PERMIT

SEWAGE DISPOSAL SYSTEM

P 33041

SUBDIVISION Sandy Hill Estates ROAD 2401 Wood Stream Court LOT 11

INDICATE NORTH - NAME ADJOINING ROADWAY AS BASE LINE.
WOOD STREAM CT

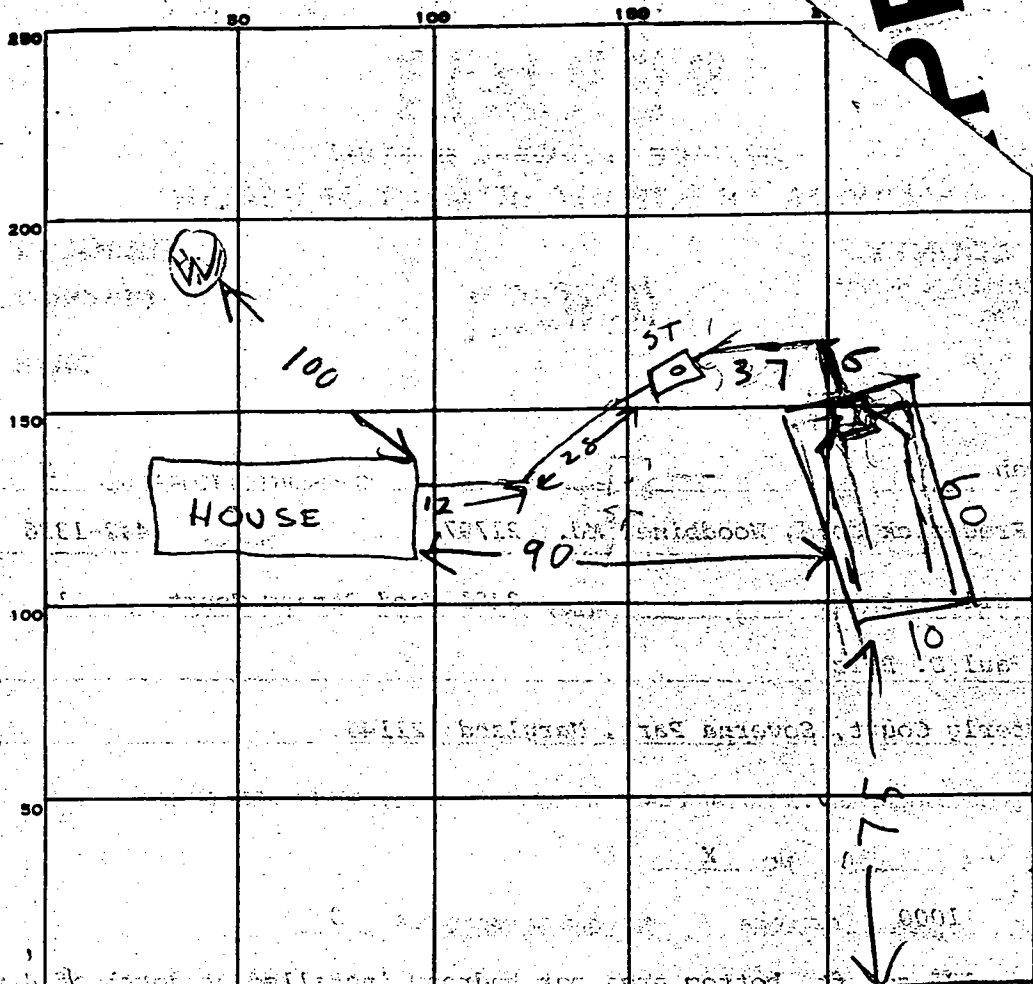
8/15/83 O.K. to use trench 4' inlt, 8' max depth & 158 sq ft. bottom area / bedroom F.S.
10/17/83 O.K. to use 8' wide shallow trench ~60' long for total of 474 sq ft. bottom area F.S.

SEPTIC TANK, LEVEL 6 CLEANOUTS OK

REMARKS ST & HOUSE CONNECTION OK. 8-12-83 CWilliam

11/3/83 LEACHING BED OK
